**Airspace Change Proposal
Stage 2a**

**London Southend Airport Design
Principle Evaluation - Annex**

ACP-2018-90

CPJ-5641-RPT-020 V1.1

Figure 1: Departure Options Runway 05 - Northeast

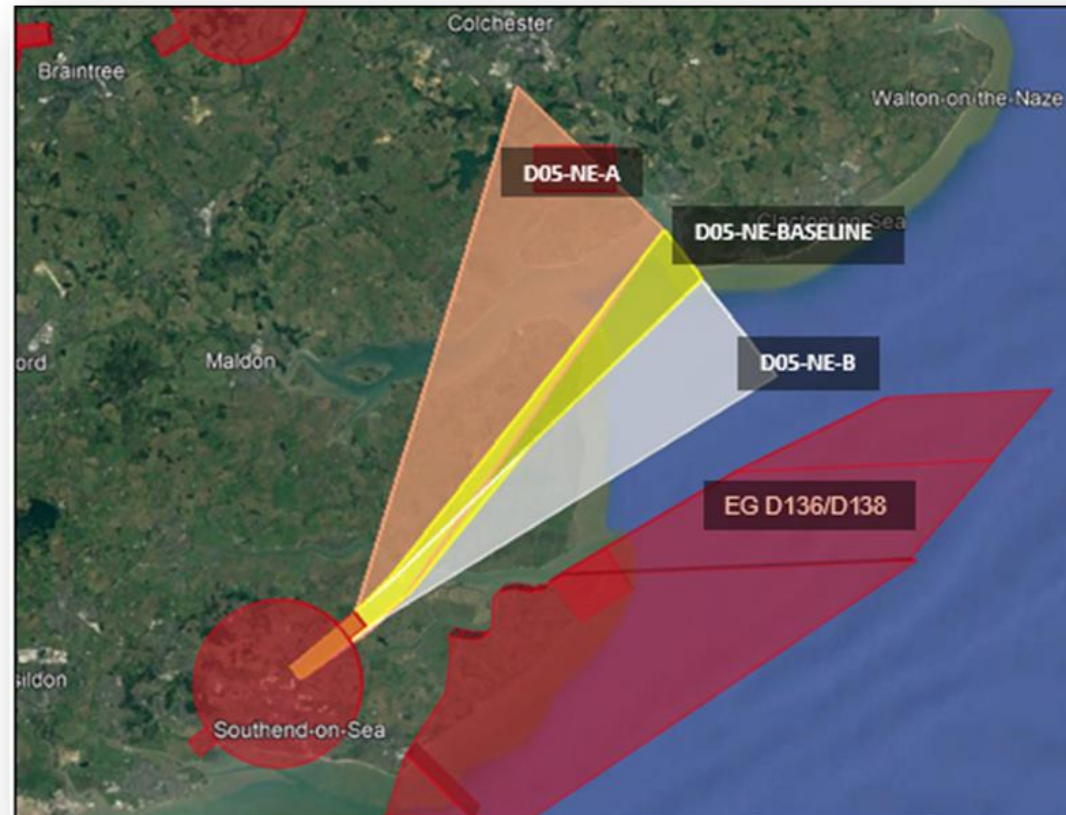
NE – A and B – The table provides an amber RAG rating for DP 4 – Tranquillity. It would appear that the A and B routes have been scored because of conflict with a sensitive area. The map and any information outlined in the booklet gives very little detail on the precise nature of the sensitive areas that are analysed beyond the Shoeburyness Danger Area. ECC considers that there are sites that may be considered sensitive areas (e.g. environmentally sensitive, noise sensitive schools, independent living accommodation etc), and these should be clearly identified and understood. Furthermore, the table should provide a brief overview to justify the rating, so that all partners are aware of why a specific rating has been applied. This will assist future review and ensure that the process is clear, logical and transparent for partners.

DP10 – Systemisation - Similarly to the comments set out above the table scores this as amber with ‘possible conflict’ as the justification. In reviewing this table, it is recommended if the justification could provide a clear understanding of the conflict or systemisation issues that may arise, so that all partners are aware.

This is welcome feedback from our stakeholder, however the detail given at this stage of the process is more in depth than the current assessment we are carrying out. Further in the ACP process, at CAP1616 Stage 3, when we reduce our options and refine the swathes to more concise routes, we will consider and evaluate climb gradients and accurate tracks.

Figure 2: Departure Options Runway 05 - Northwest

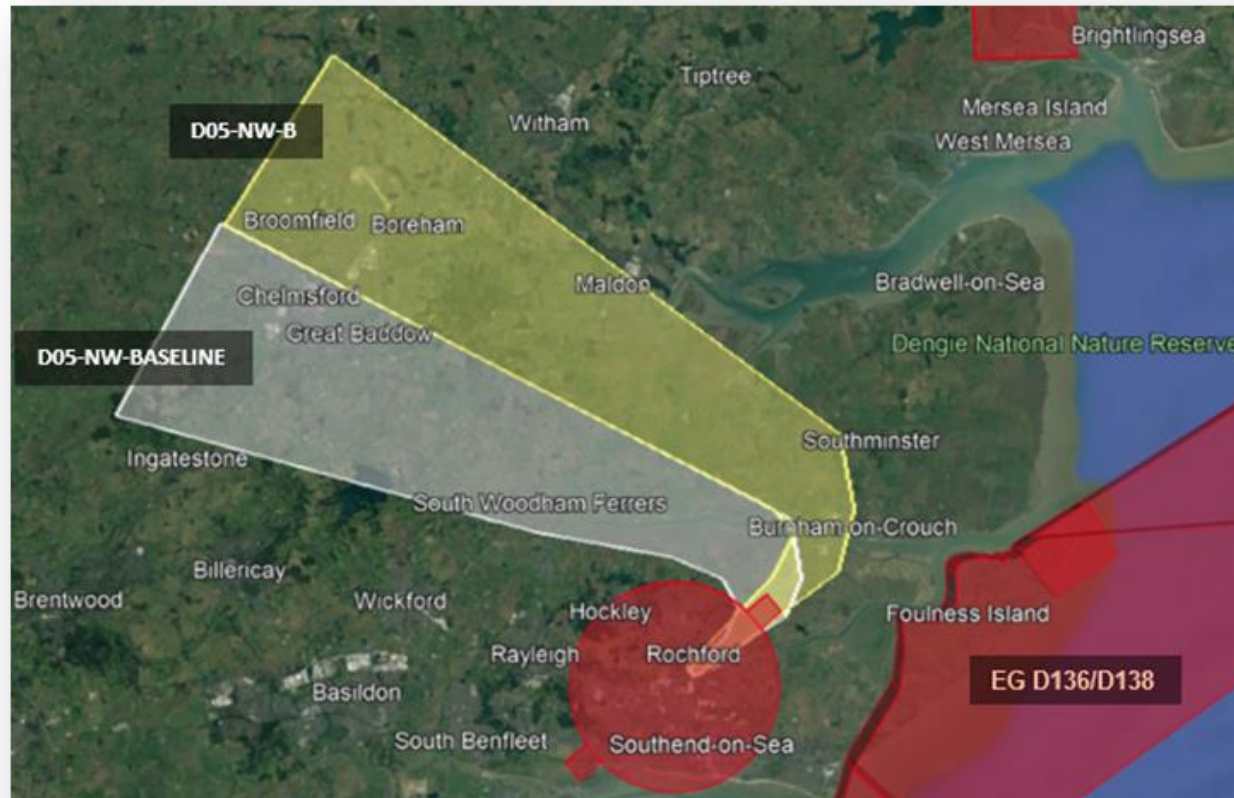
ECC notes that DP2 entitled overflight states that “the New Procedures should not increase the number of people overflown by aircraft using the Airport and where possible options that provide a level of dispersion should also be considered”. The analysis of the impact for runway 05 – North-West highlights NW-B as amber due to “different communities, possibly at lower level”. ECC questions the application of DP2, as this justification does not demonstrate whether there has been increase in persons overflown, which is the purpose of the DP2. From the brief justification text, it is considered that the weight to legacy routes is something that is being assessed within DP2, which is not the purpose of DP2. ECC does consider that within the analysis due consideration should be given to legacy routes, and therefore following this exercise a review of the precise wording for the Design Principles may be required prior to advancing to the next stage in the CAP1616 process.

NW-A scores DP4 as amber while DP4 (tranquillity) for NW-B is green. ECC considers that the information presented does not clearly allow for an appreciation of the impact on sensitive areas. Our overarching response highlights some of the sensitive areas that should be considered when reviewing the impact of airspace route changes, and it is welcomed that the justification demonstrates a review of such information and then appropriate RAG score given with a supporting justification.

This is welcome feedback from our stakeholder, however the detail given at this stage of the process is more in depth than the current assessment we are carrying out. Further in the ACP process, at Stage 3, when we reduce our options and refine the swathes to more concise routes, we will consider and evaluate climb gradients and accurate tracks.

Figure 3: Departure Options Runway 05 - South/ Southeast

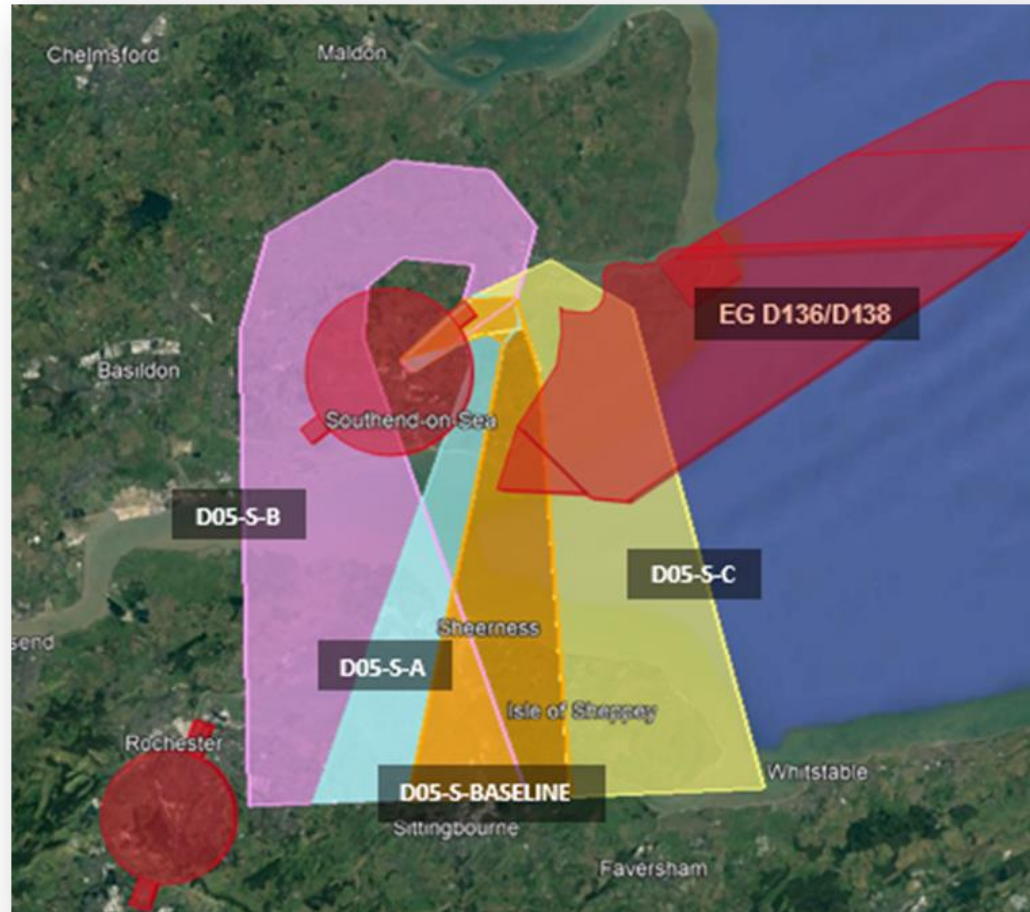
‘05 S B used to be the only departure procedure for runway 05, which was replaced by 05 S A few years ago with aircraft departing 05 and flying over the villages of Stonebridge, Little and Great Wakering Barling Shoeburyness in the climb but restricted on altitude by London ATC both S A and S B should be replaced by S C avoids flying over the population and wildlife areas therefore making the departures safer, but would involve coordination with the military DA authorities, as there will be scheduled services using this route pre planning of their activities wouldn’t be an issue avoiding the departure times of aircraft.’

ECC notes that for Runway 05 – South/South-East there are three possible options S- A, S-B and S-C. It is appreciated that there are a few Design Principles DP4, DP5, DP6, DP10, DP11 and DP13 that for some or all airspace route options have been scored amber and in one case red. In reviewing the information that is set out ECC questions whether the assessment has been consistent in the application of whether the benefits of continuous climb and the aircraft reaching its cruising altitude quicker have been consistently applied. ECC acknowledges that where an aircraft can operate continuous climb procedures and reach a cruise altitude quicker the flight can reach the most fuel efficient conditions. It would therefore be appreciated if the analysis could provide some justification as to whether additional track miles may/may not facilitate the ability for the aircraft to engage in continuous climb and possibly reduce a stepped climb which would increase fuel usage. Furthermore ECC questions whether there may be options for using alternate routes for this option and facilitate respite options for the local communities.

This is welcome feedback from our stakeholder, however the detail given at this stage of the process is more in depth than the current assessment we are carrying out. Further in the ACP process, at CAP1616 Stage 3, when we reduce our options and refine the swathes to more concise routes, we will consider and evaluate climb gradients and accurate tracks.

Figure 4: Departure Options Runway 23 - Northeast

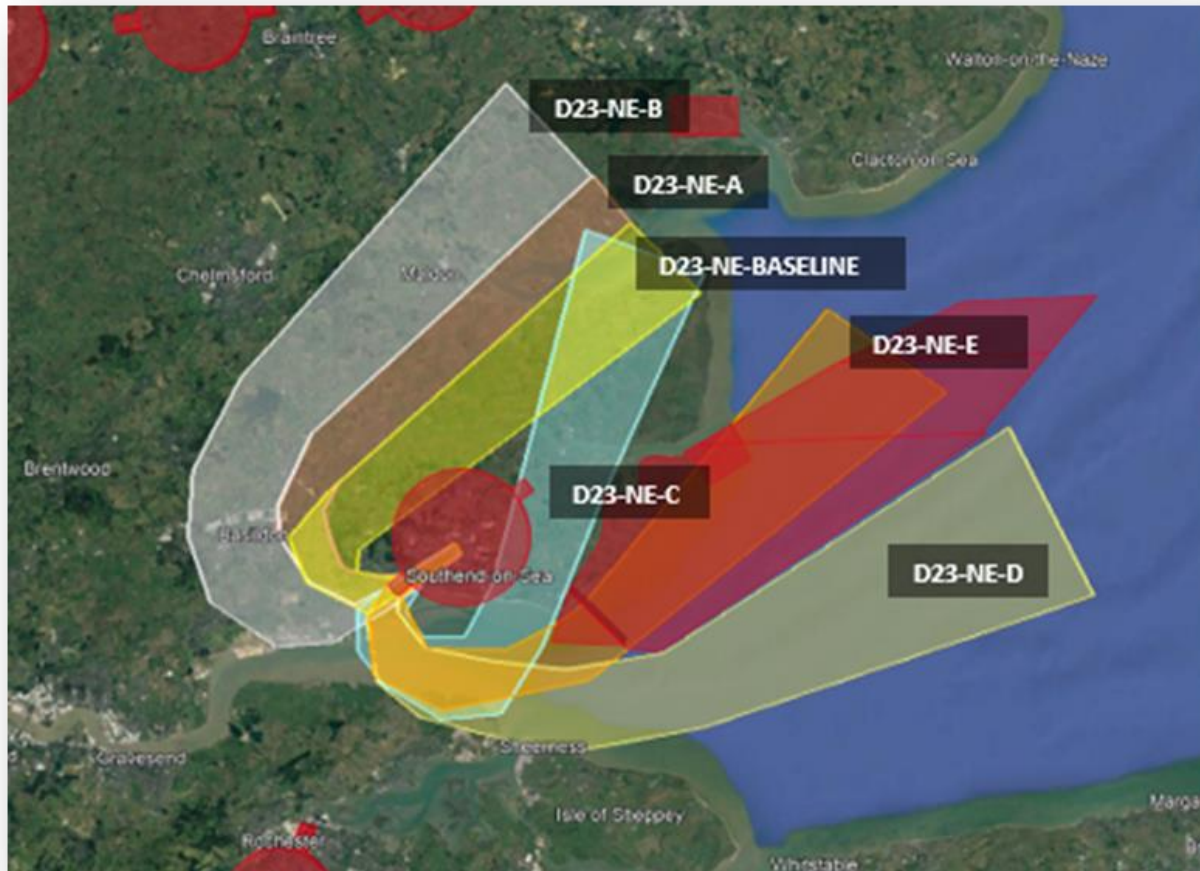
‘No; Departures 23 Northeast D23 NE A DP2 Over flight DP3 Noise DP4 Tranquillity procedure to be re written to ensure the aircraft are 1,000’ higher at the point before they turn and change acceleration altitude to 4000.’

ECC notes that for NE-B, DP2 (Overflight) is scored as amber and it states in the text 'potential increase in overflight of Canvey Island and Basildon (at a higher level)', it also states for DP13 (PBN) that it is amber due to 'increased potential for step climb'. ECC questions whether the ability to achieve a higher altitude would not allow for continuous climb, and the reason for traffic being held down. It is assumed that this is due to conflict with traffic from London City Airport and other London airports within the area. Clarification is sought to ensure that all partners fully appreciate the conflicts and the implications for achieving more efficient flight procedures.

ECC notes that NE-C is scored amber for DP7 (airspace dimensions) due to conflict with the IFP Danger Area, ECC considers that there may still be operational used for this route as it may provide respite opportunities.

‘Welcome an appreciation of when this revised route may be used, and if there are restrictions on use how useful it may as a potential route to provide some communities with respite? An understanding of the noise exposure would be appreciated.’

Criteria 8 Airspace Complexity - I note the explanatory qualitative assessment, but the outcome remains green. This is inconsistent with the criteria 7 and the interaction with the Shoeburyness Danger Area. The Assessment needs to be evaluated in a consistent and logical manner. Criteria 7 and 8 should be consistent in their assessment.

'Unfortunately, these swathe illustrations and text do not provide us with enough information to understand the impact on our operations. We need to see detail of horizontal and vertical limits of proposed controlled airspace.'

LSA have amended the description and RAG score of DP4 to reflect Southend City Council’s comments. For DP2 -Overflight which is assessed as green, the Evaluation Criteria states ‘No different to today or less people overflown’ which is correct when related to the baseline so the original assessment stands.

The change in track miles is against the baseline and this option would be an increase from that.

For DP2 -Overflight, which is assessed as green, the Evaluation Criteria states 'No different to today or less people overflown' which is correct when related to the baseline so the original assessment stands. We have considered the remaining comments however they have not altered our assessment of the associated DPs.

Figure 6: Departure Options Runway 23 - South/ Southeast

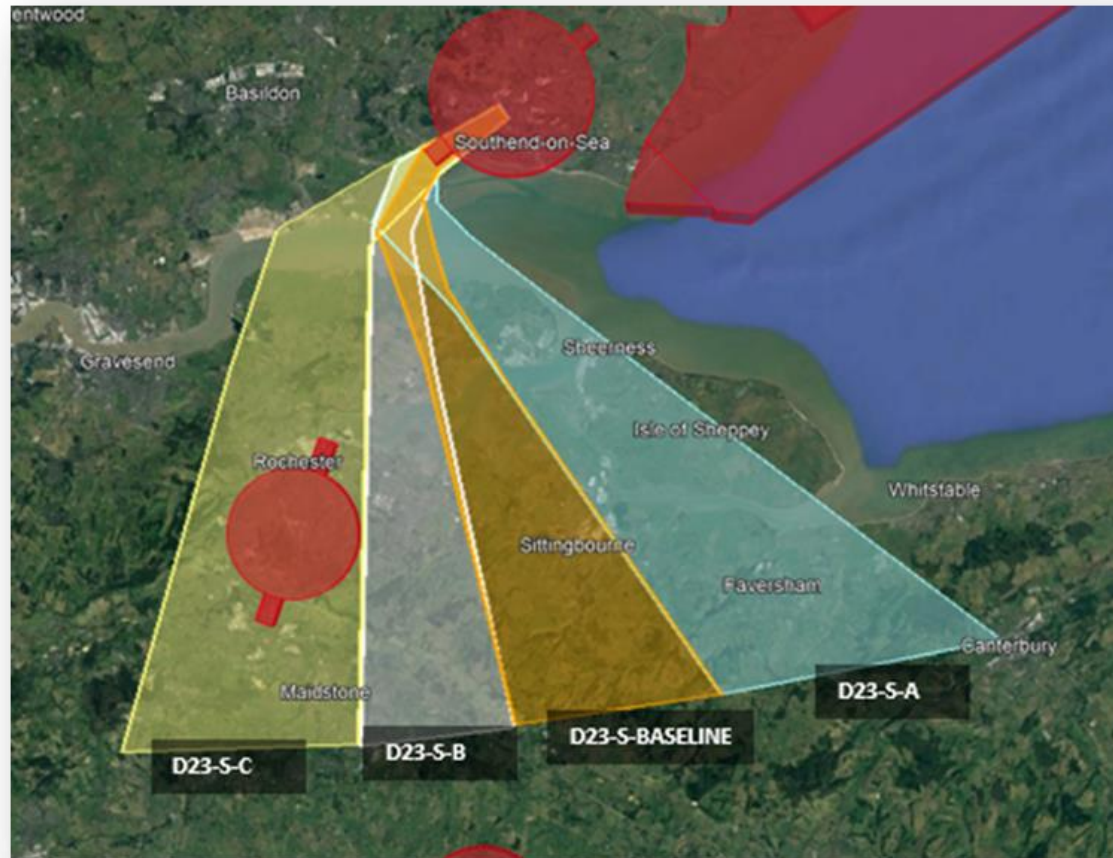
ECC Notes that NW-C is the swathe that replicates current operations the most, therefore the red scoring for DP2 (overflight) and DP3 (noise footprint) is questioned, it states that there will be an increase in overflight. ECC also welcomes information on which of these three options would facilitate continuous climb procedures. It is noted that NW-C has an increased likelihood of a stepped climb procedures.

ECC notes the amber rating for DP4 (tranquillity) for NW-B and similarly to other airspace change proposals welcomes further information on the sensitive arears and locations that have been reviewed as part of this analysis.

Figure 8: Arrival Options Runway 05 - South & East

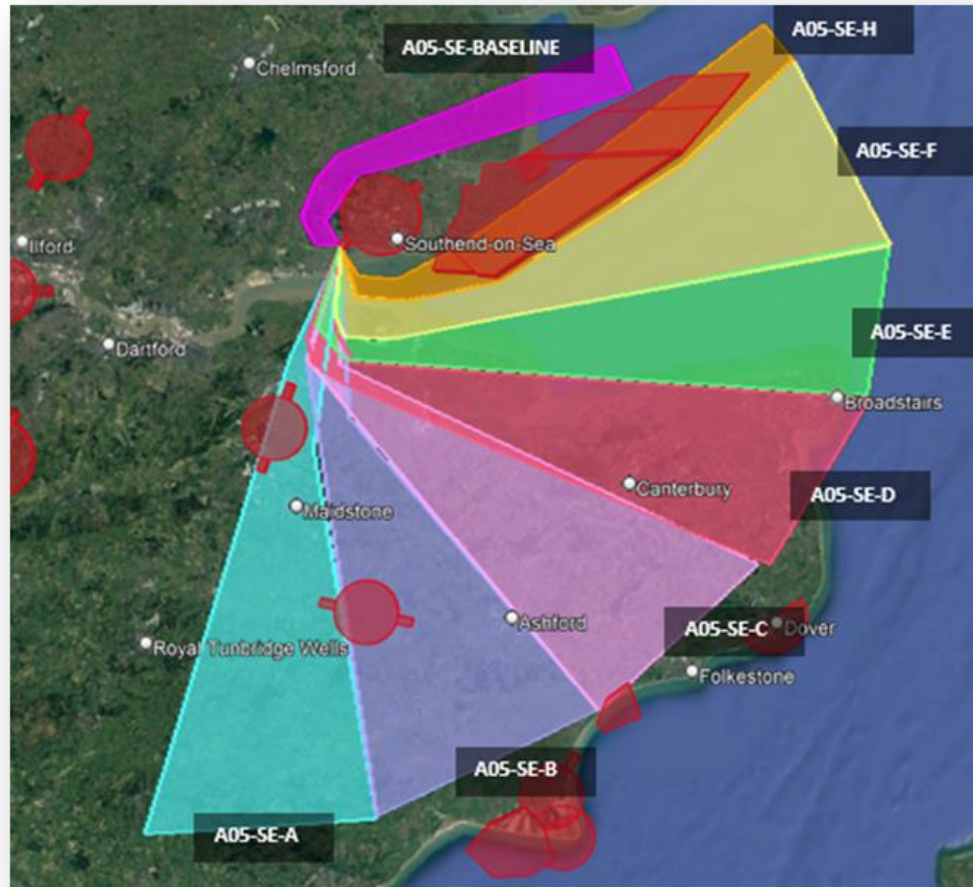
‘Welcome an appreciation of when this revised route may be used, and if there are restrictions on use how useful it may as a potential route to provide some communities with respite? An understanding of the noise exposure would be appreciated.’

'Unfortunately these swathe illustrations and text do not provide us with enough information to understand the impact on our operations. We need to see detail of horizontal and vertical limits of proposed controlled airspace. This illustration demonstrates how removed from its original intent Stage 2 of CAP1616 has become - the Options effectively include the entire SE corner of England.'

'Most of the points for doe a05seh would be brought into conflict as per the previous answer , there is no operational cost benefit'

'As mentioned above, it's another option with the added drawbacks with the Firing Range.'

Yes, this would be a correct assumption.
